HISTORIC LANDMARK COMMISSION
OCTOBER 22, 2012
CERTIFICATE OF APPROPRIATENESS
LHD-2012-0030
4001 Avenue D
Hyde Park Local Historic District

Add front and rear dormers and a rear, one-story screened porch to a c.1945 contributing house.

Existing dormer areas

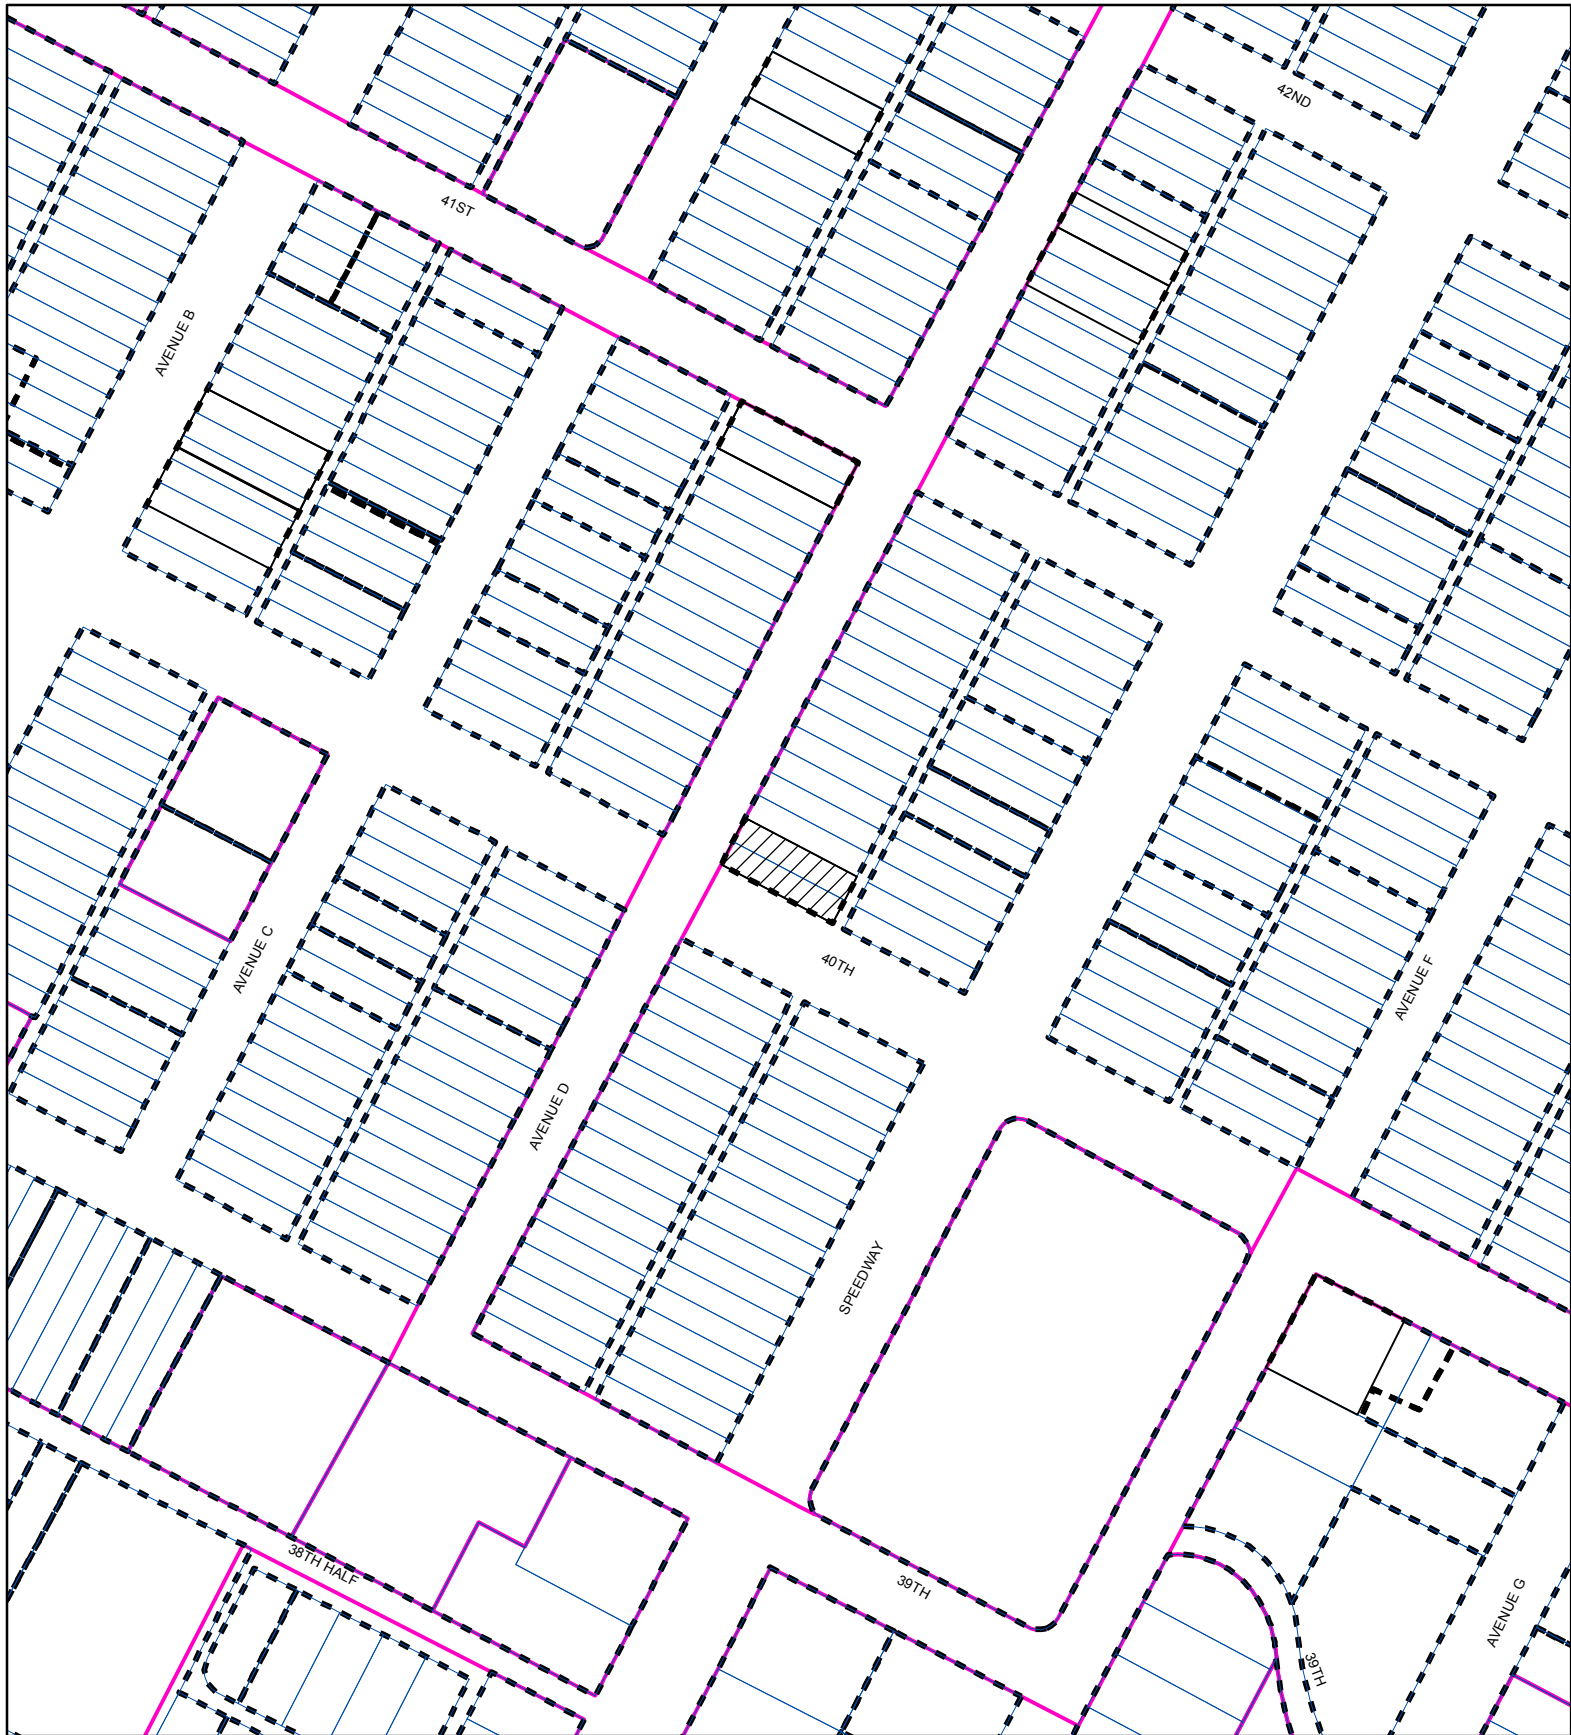
Provide documentation of existing framing conditions that indicate previous dormers and change proportions to be more vertically oriented.
